DOE/EIS-0064

Final Environmental Impact Statement
(Final Statement to ERDA 1545-D)

Rocky Flats Plant Site

APRIL 1980
Volume 3 of 3
RESPONSES TO PUBLIC COMMENTS

Fig. 1 Rocky Flats Nuclear Weapons Plant and proposed housing development area. Isopleths are labeled in disintegrations per minute per gram of whole soil calculated from values in (2).

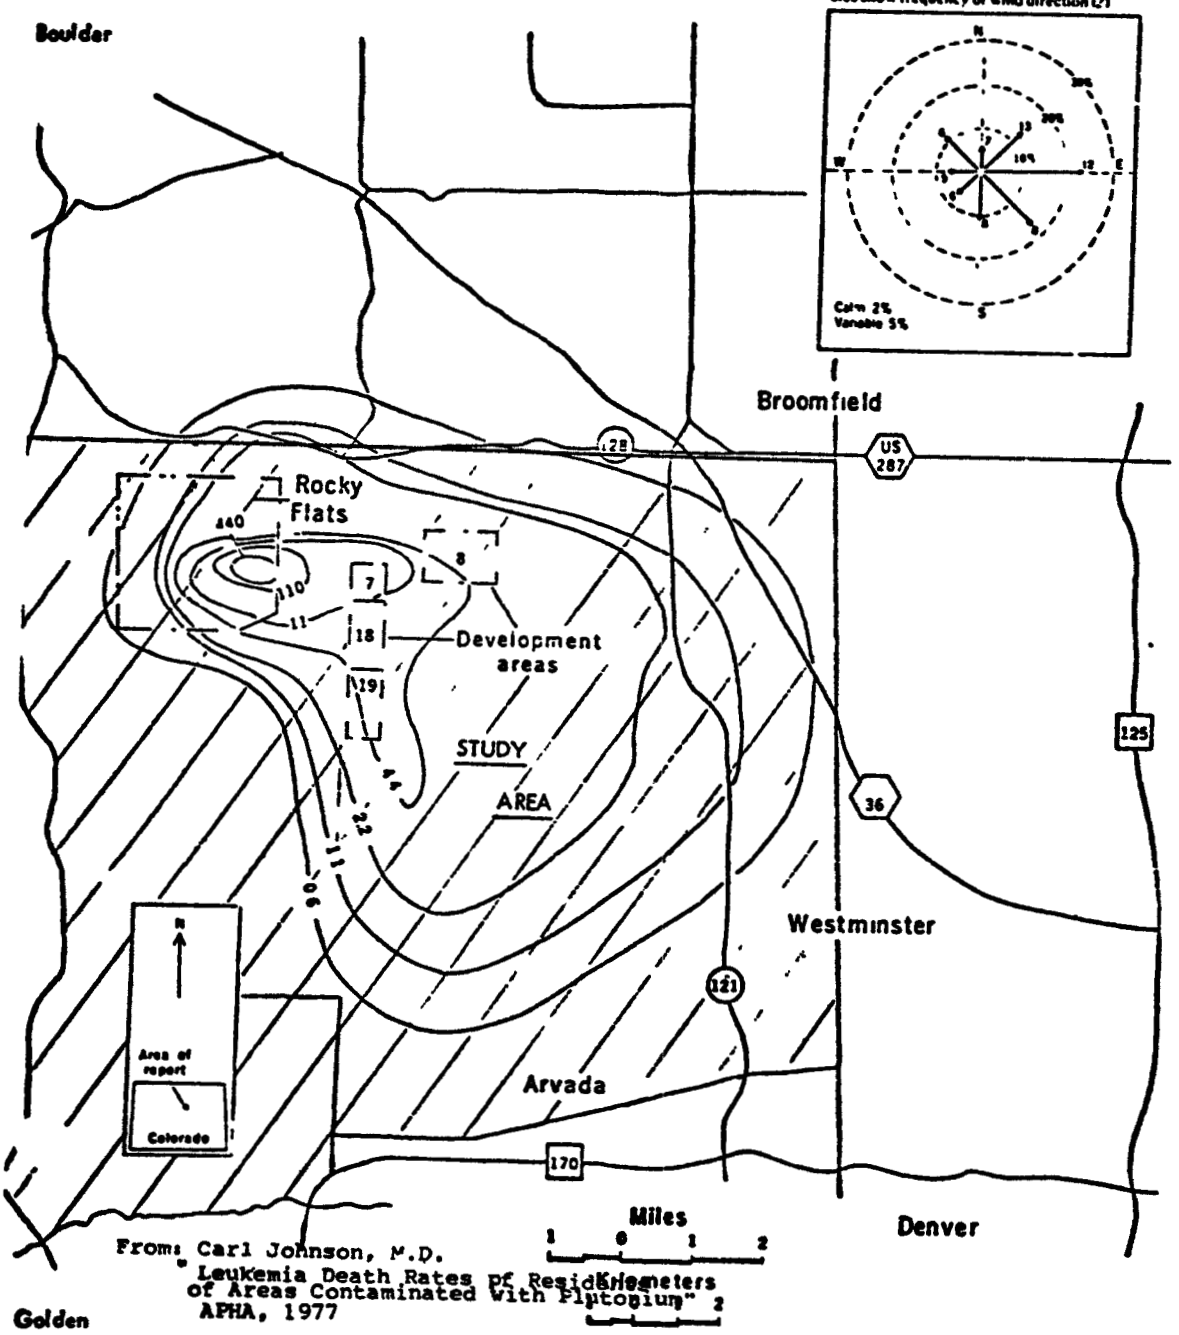
From: Carl Johnson, M.D.
"Leukemia Death Rates of Residents of Areas Contaminated With Plutonium"
APHA, 1977

DOE STAFF RESPONSE TO THE COLORADO ENVIRONMENTAL HEALTH ASSOCIATION COMMENTS ON THE ROCKY FLATS PLANT DRAFT ENVIRONMENTAL IMPACT STATEMENT (ERDA-1545-D)

Figure 4. HEPA filter particle removal mechanisms relationship to particle size.

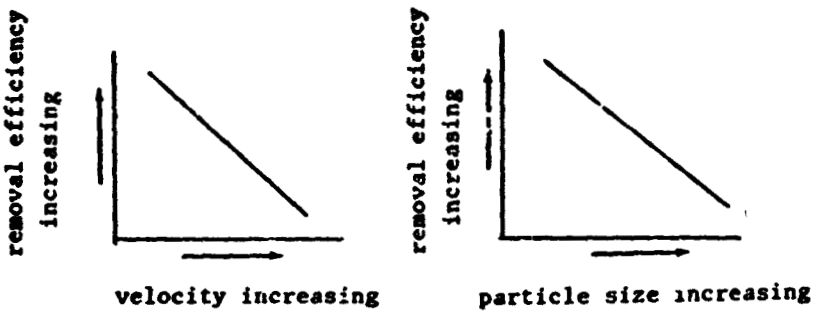
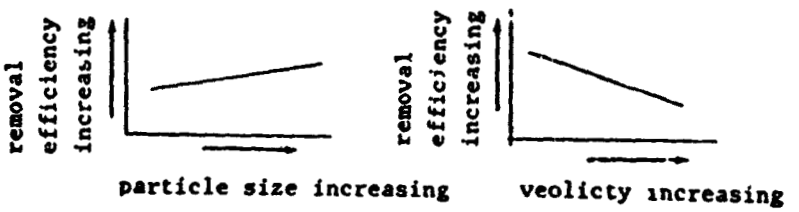
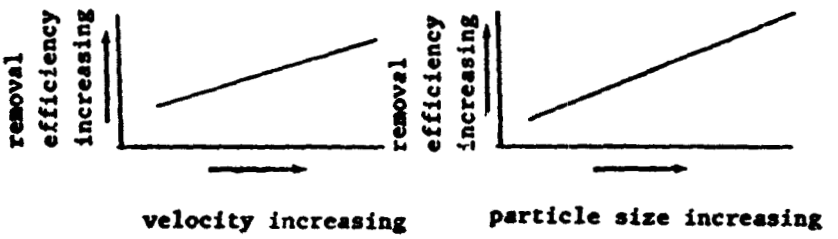
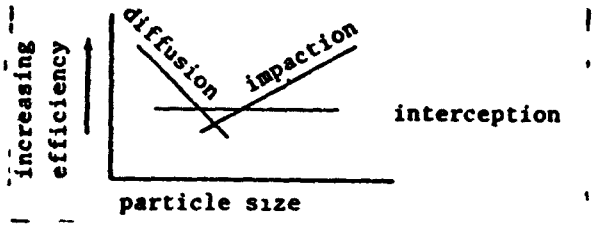
1. How adequate is the present air filtration system at RFP to catch very small particles of plutonium, americium, beryllium, and other radio-active or toxic elements or compounds involved in plant operations? I understand the filters are tested for particles of about 0.3 micrometers diameter, but that the smaller size particles (0.1 down to 0.01 micrometer size) may be able to get through the filters and would be very dangerous to inhale.

The device selected for nuclear installations is the HEPA filter which is a passive air cleaner that remains functional in all operating or static conditions. This filter is composed of a glass fiber mat supported in a metal or wood frame. The glass fibers are sized to take the best advantage of the three removal mechanisms

operating--interception, impaction, and diffusion. Attempts to theoretically calculate the efficiency of a HEPA filter have not been completely successful, but experimental data and test data are used to ascertain their performance The combination of the removal mechanisms predict a particle size of maximum penetration and this has been verified in the operating data. At Rocky Flats HEPA filters are individually tested with a 0.3μ aerosol before installation and are leak tested after installation. The acceptance test of a filter utilizes a laser particle size analyzer to measure the efficiency in ten size increments from ~ 0.1μ diameter particles to >1.0 micron diameter. Figure 4 illustrates the mechanisms and their relationships

Test data in the cited references show that the overall efficiency is greater than 99 97% removal of all particles except those at the most penetrating size at which the efficiency must be at least 99 97%. Experiments using up to three HEPA filters in cascade or series support the basic theory that each stage functions separately and the efficiency is described by an equation of the type
